CITY PLAN COMMISSION STAFF REPORT

Project Name
The Reserve & The Porches

Request
CD-CPC-2022-00136
Rezoning to UR/MPD

PROFESSIONAL STAFF RECOMMENDATION
Docket #14 Recommendation
Approval with Conditions

SITE PLAN

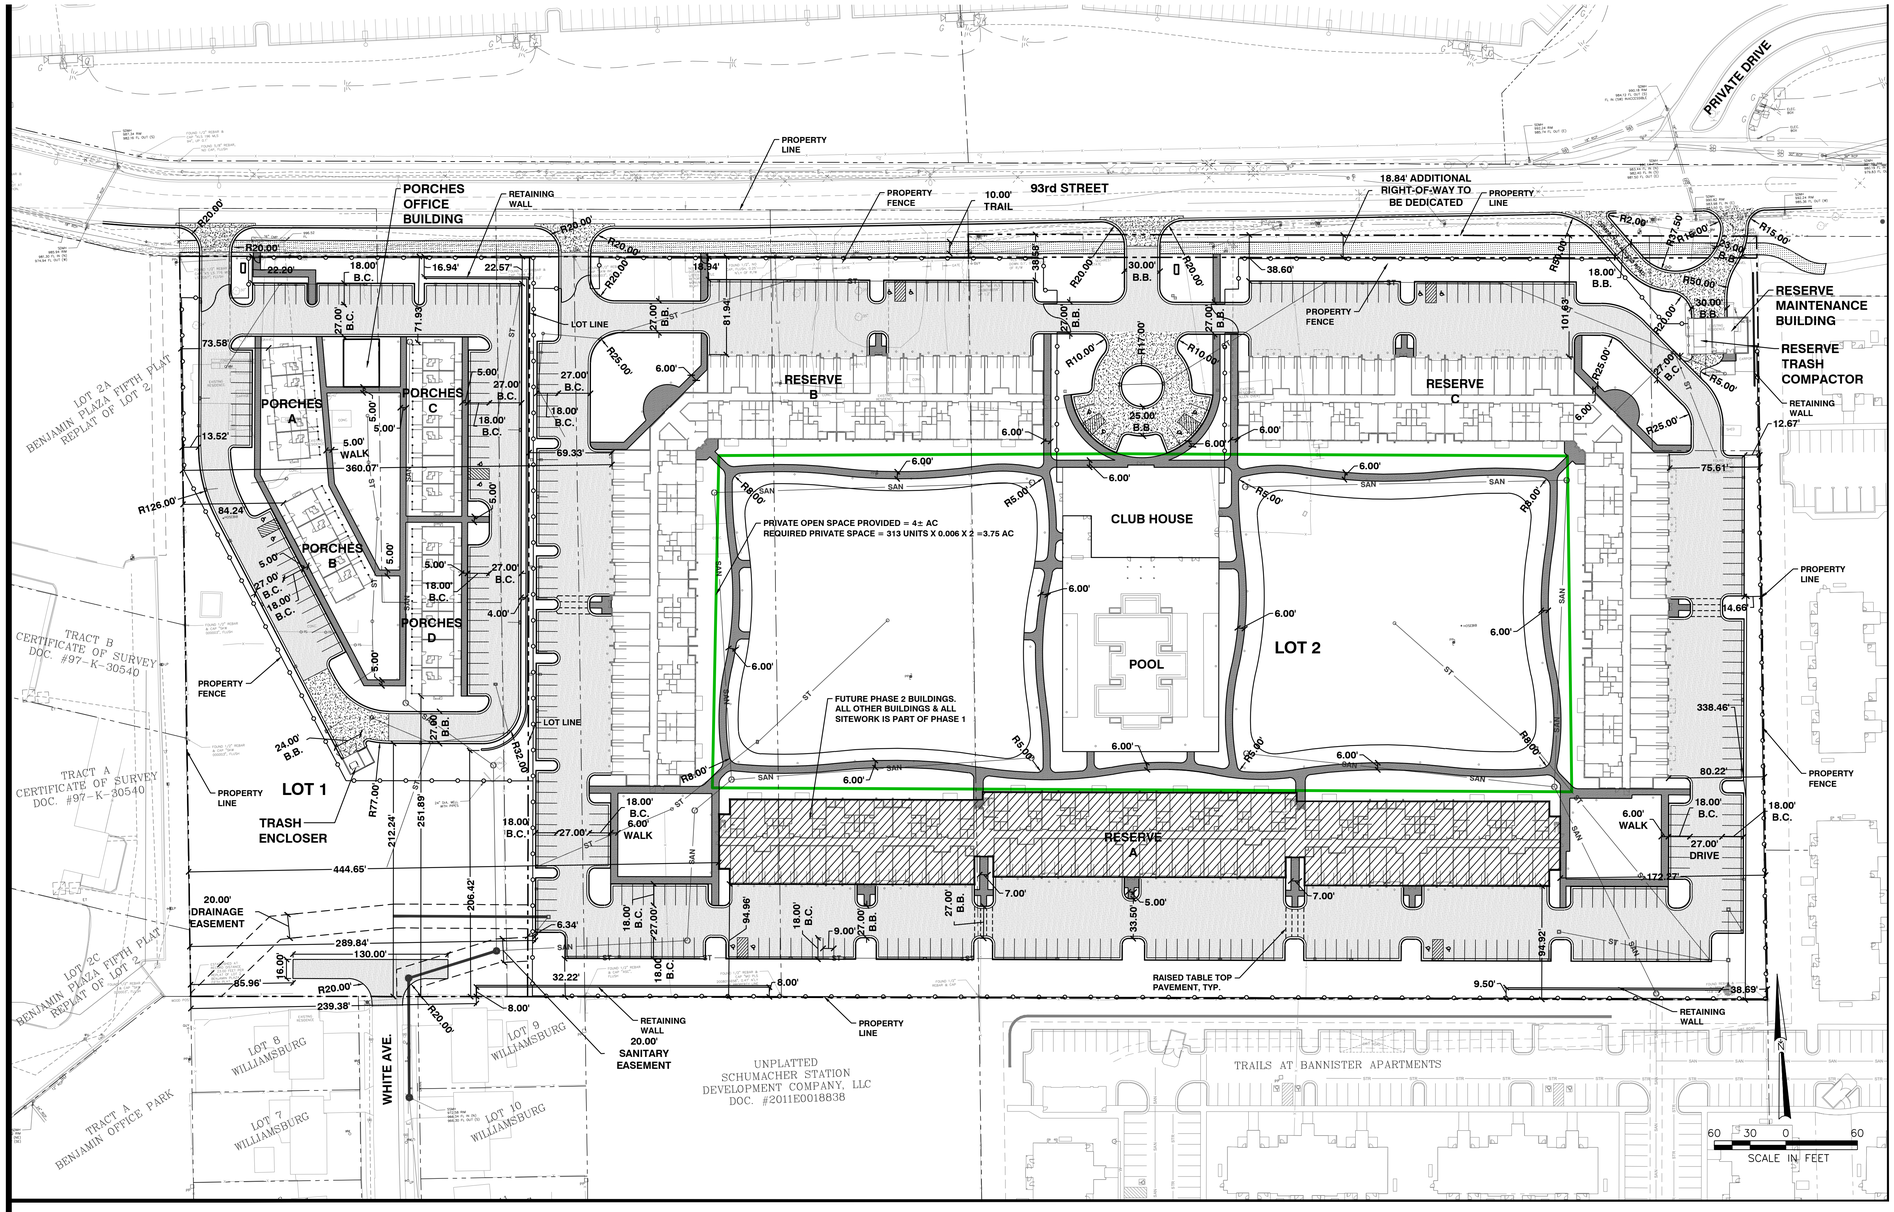
The applicant generally complies with 88-425 (landscaping standards of the Zoning and Development Code). Staff has asked the applicant to comply and provide the required screening on the western perimeter of "The Reserve" to reduce headlights from entering residences of "The Porches."

6. The applicant shall show perimeter landscaping of vehicular use areas in compliance with 88-425-05 specifically along western, southern and eastern perimeter of "The Reserves" prior to ordinance request.
